**SUSQUEHANNA STEAM ELECTRIC STATION
PROPOSED LICENSE AMENDMENT NO. 285 FOR
UNIT 1 OPERATING LICENSE NO. NPF-14 AND
PROPOSED LICENSE AMENDMENT NO. 253 FOR
UNIT 2 OPERATING LICENSE NO. NPF-22 EXTENDED
POWER UPRATE APPLICATION RE: REACTOR SYSTEMS
TECHNICAL REVIEW REQUEST FOR ADDITIONAL
INFORMATION RESPONSES
PLA-6209**

**Docket Nos. 50-387
and 50-388**

Attachment 2 to PLA-6209
Non-Proprietary Version of the Request for
Additional Information Responses

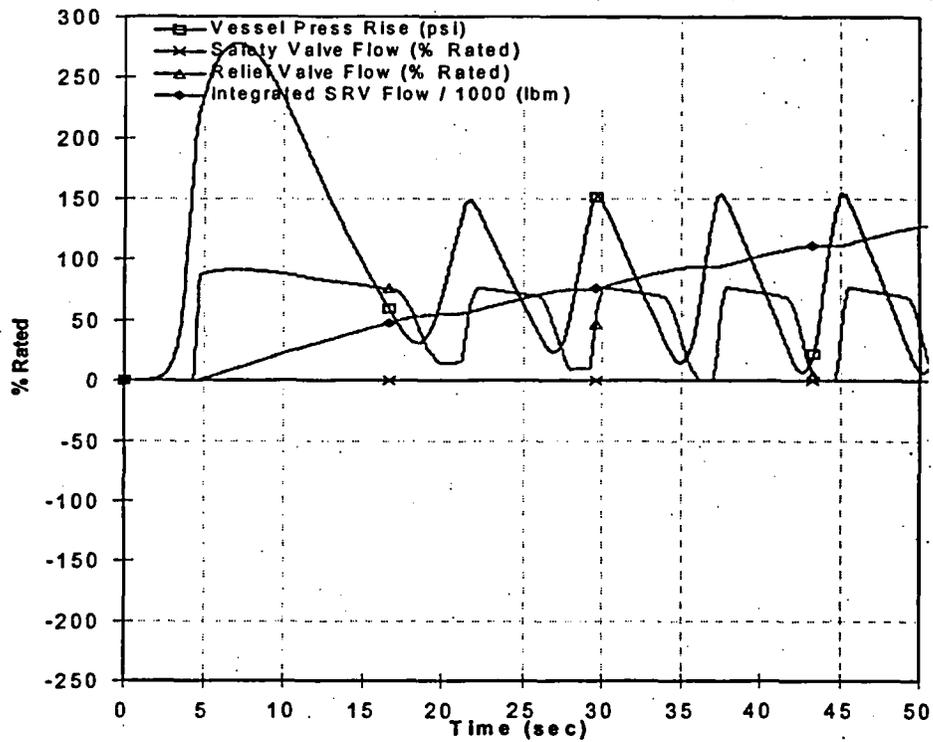
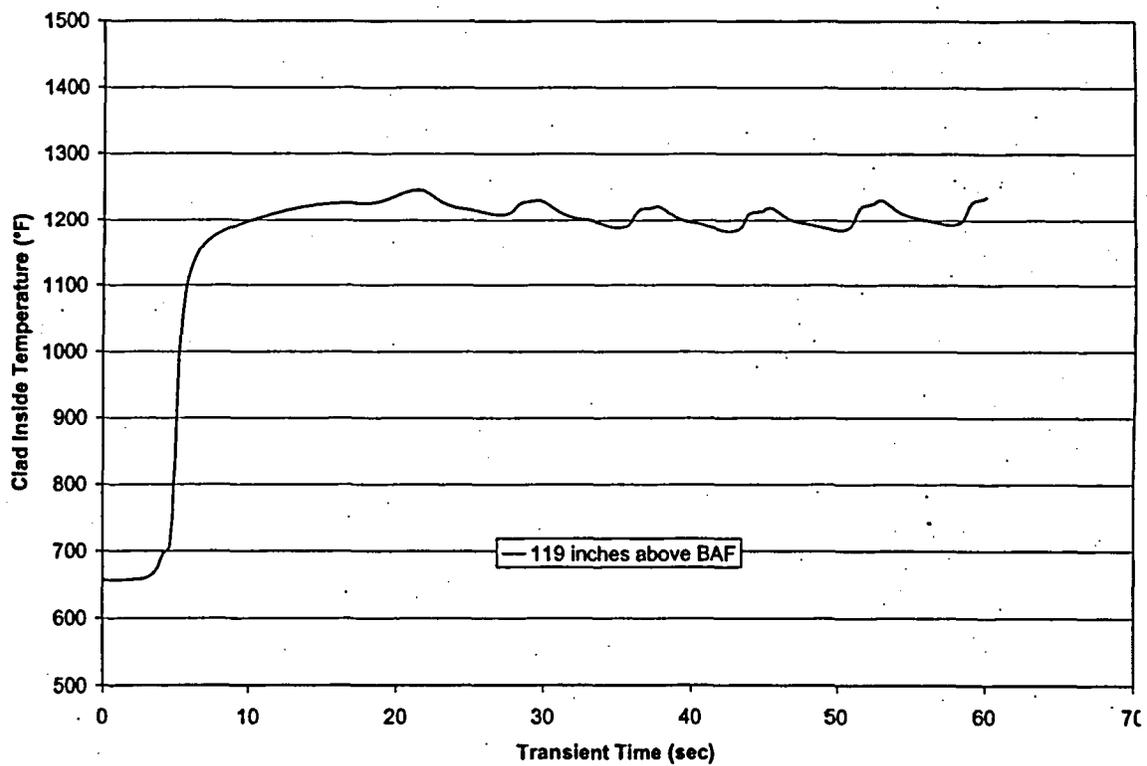
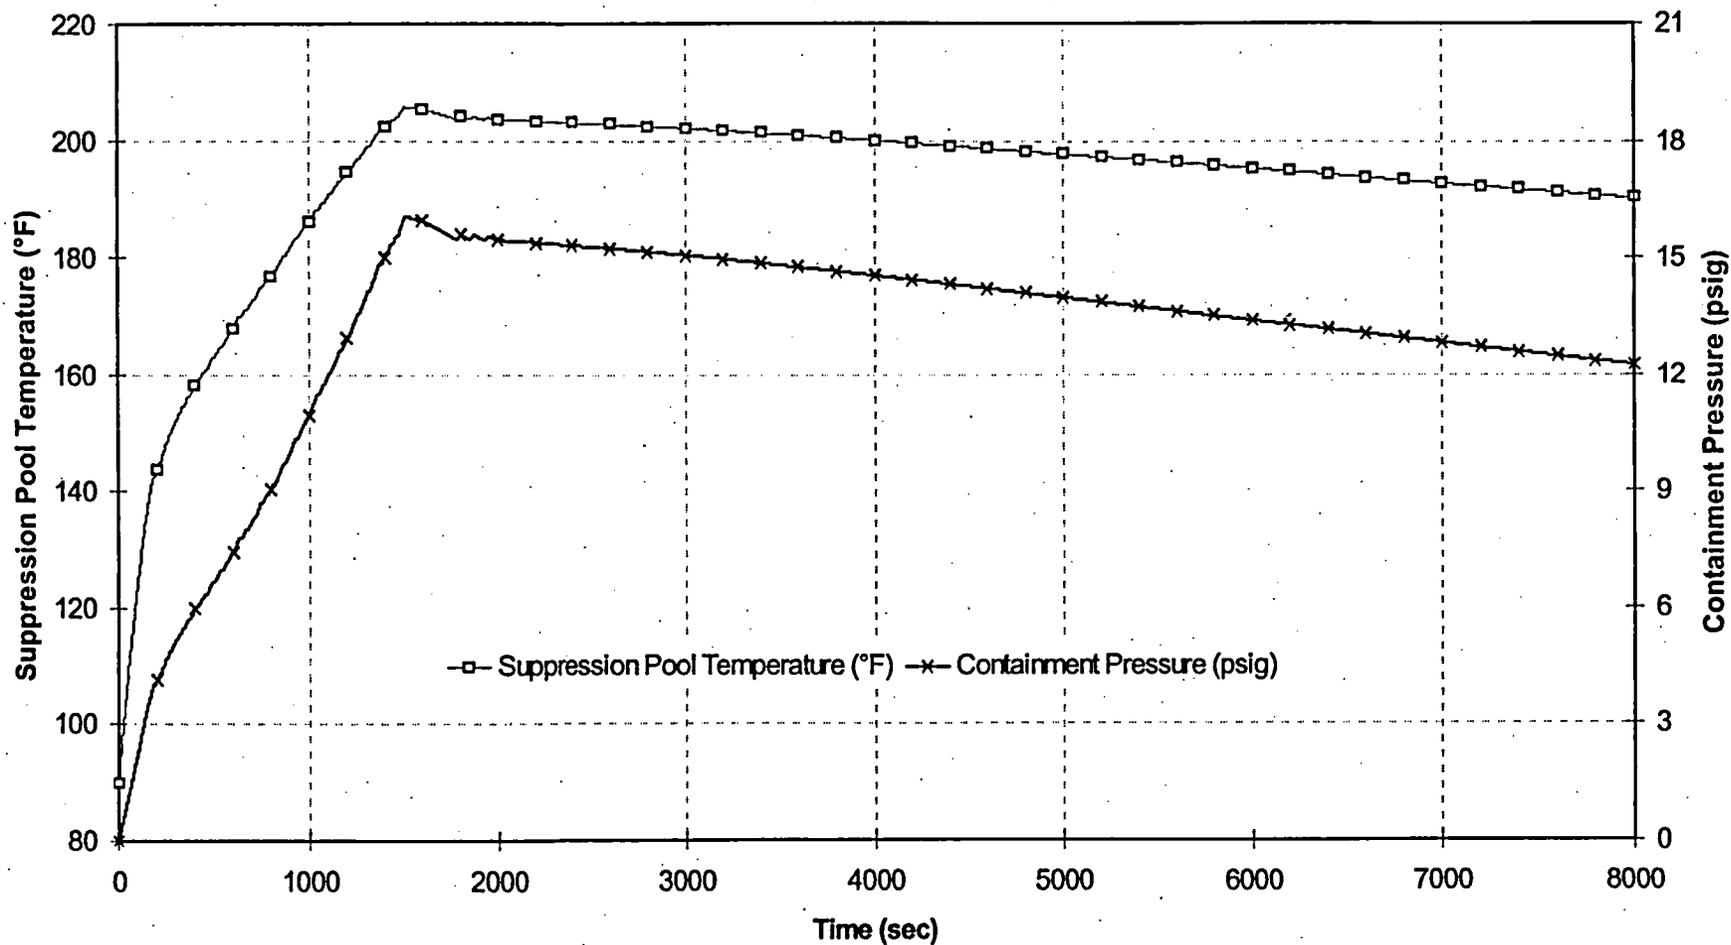
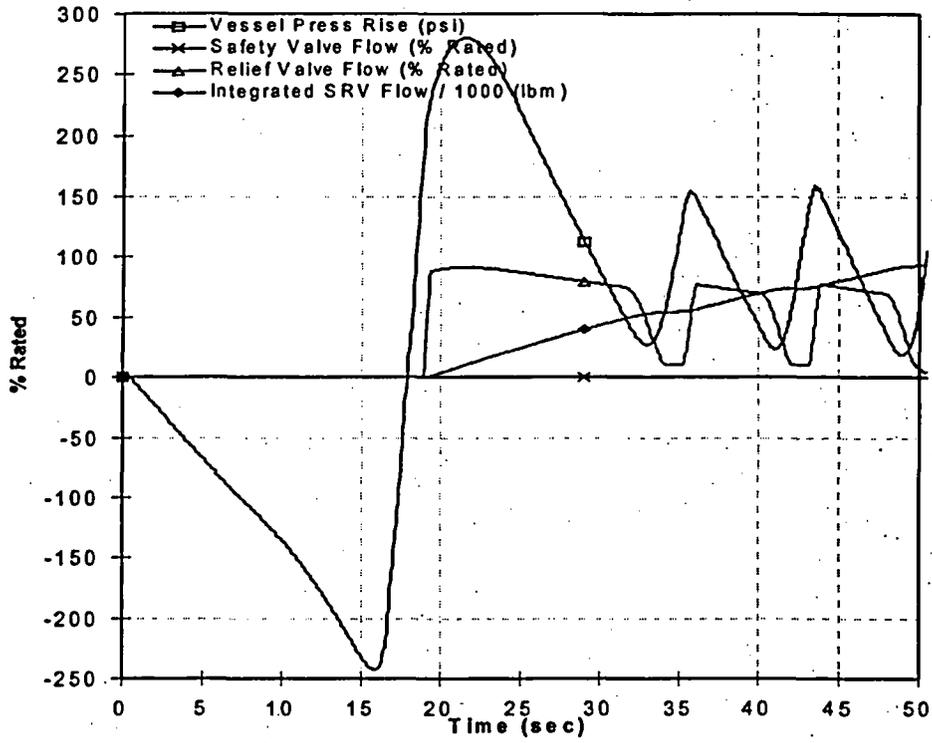
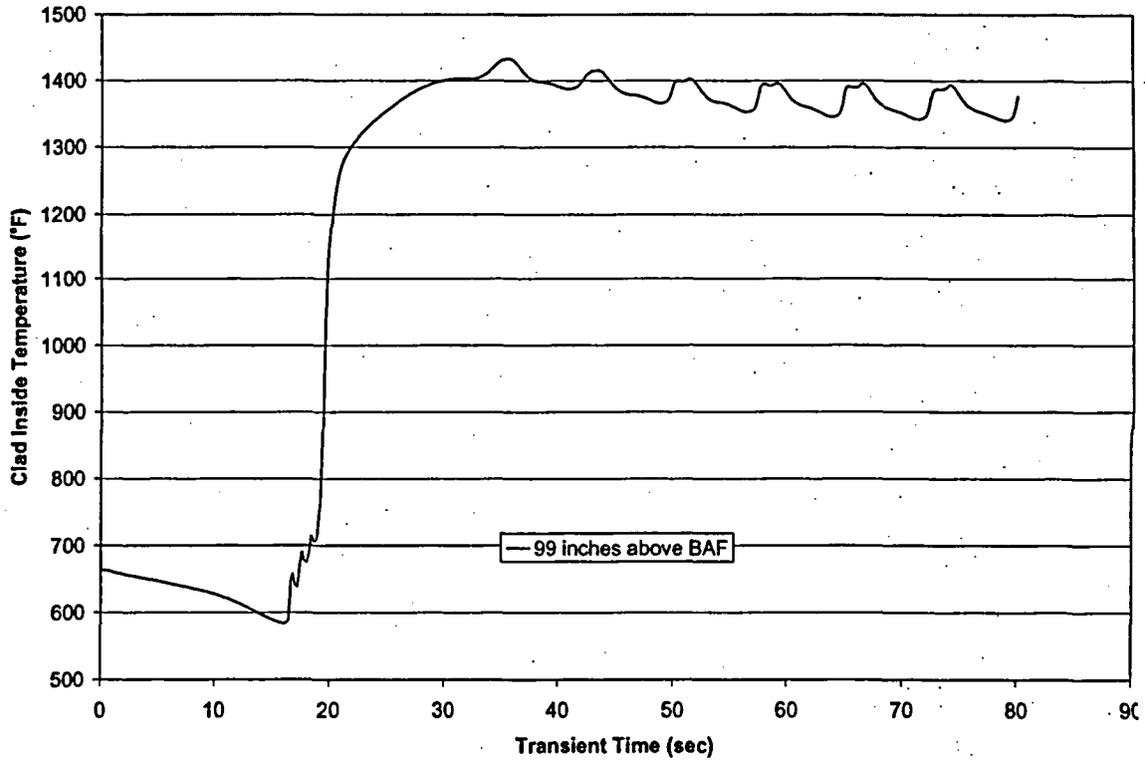
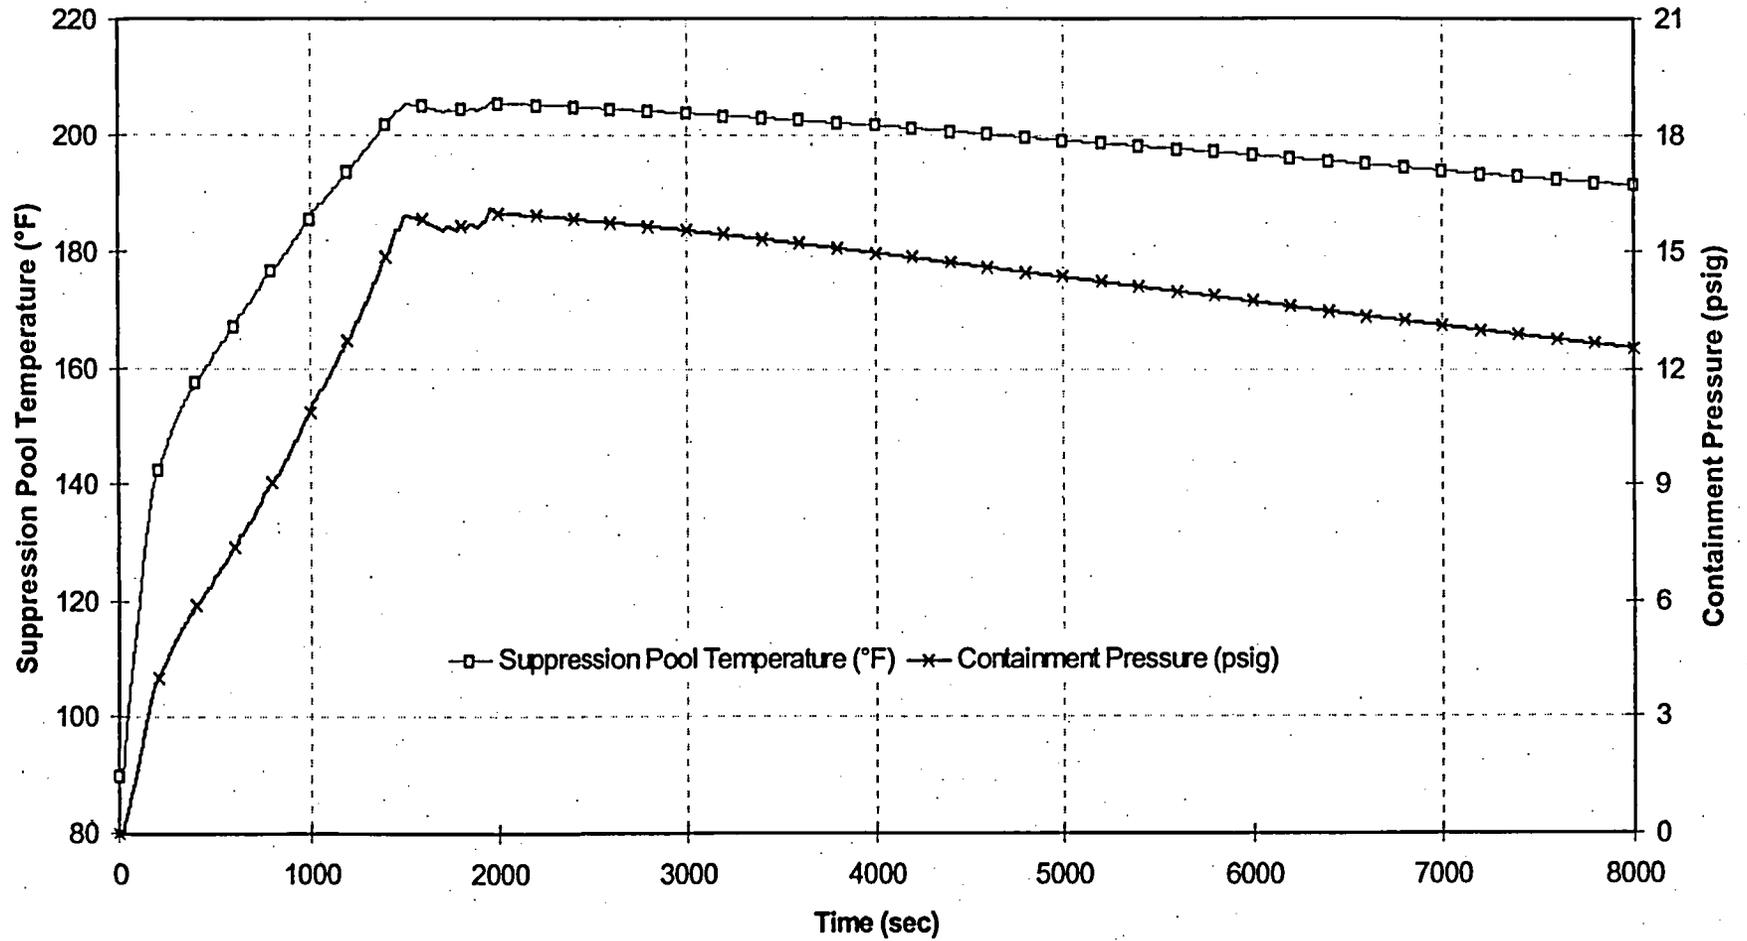
(ATWS): Provide graphs of the data presented in PUSAR Table 9-4 for the ATWS scenarios: (1) main steam isolation valve closure, and (2) pressure regulator open failure.

The tables below provide the sequence of events for limiting the main steam isolation valve closure (MSIVC) and pressure regulator failure – open (PRFO) ATWS events.

In addition, the following graphs provide the trends for: 1) the change in vessel dome pressure, relative to the initial value; 2) peak cladding temperature; 3) peak suppression pool temperature; and 4) peak containment pressure for the limiting MSIVC and PRFO events.

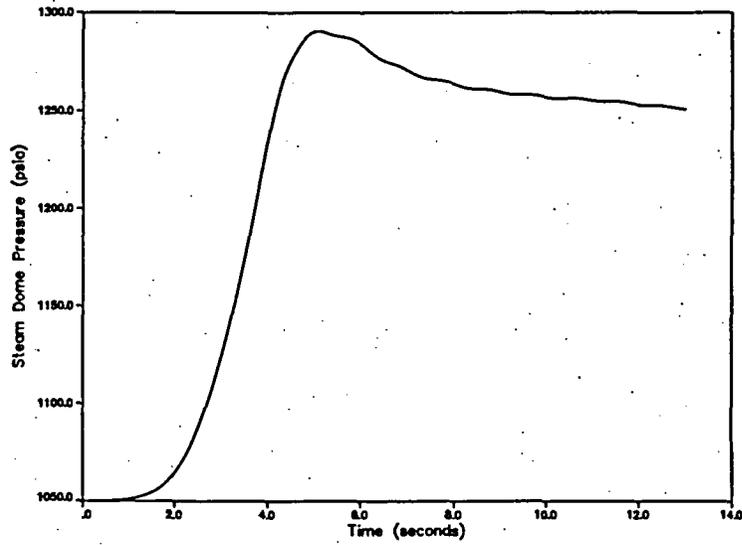
In Figure 9-8, relative feed flow appears to be linear. Is there any level control in this calculation?

Yes, the level control is present in the calculation. However, due to the time response characteristics of the level controller and the feedwater system, the change in the feedwater flow is slow relative to the duration of this transient.

This event (generator load rejection with turbine bypass failure and EOC-RPT-OOS) is a potentially limiting MCPR event and the primary purpose of the analysis is to calculate Δ CPR. The Δ CPR for this transient is calculated to occur early, at 1.98 seconds into the transient. Due to the time required for changes in the feedwater flow to reach the core, the feedwater control system has negligible effect on the Δ CPR.

**Figure 1 Reactor Vessel
Steam Dome Pressure**

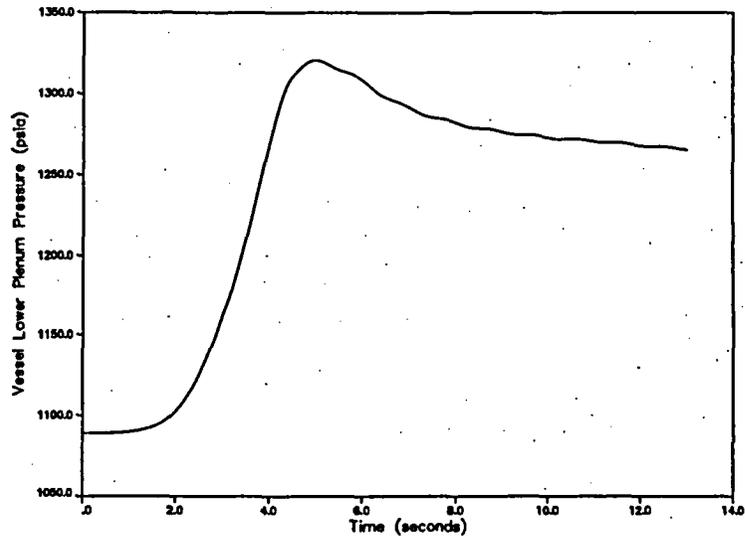
In Figure 9-29, please provide the reactor pressure plot for the Pressure Regulator Downscale Failure transient.
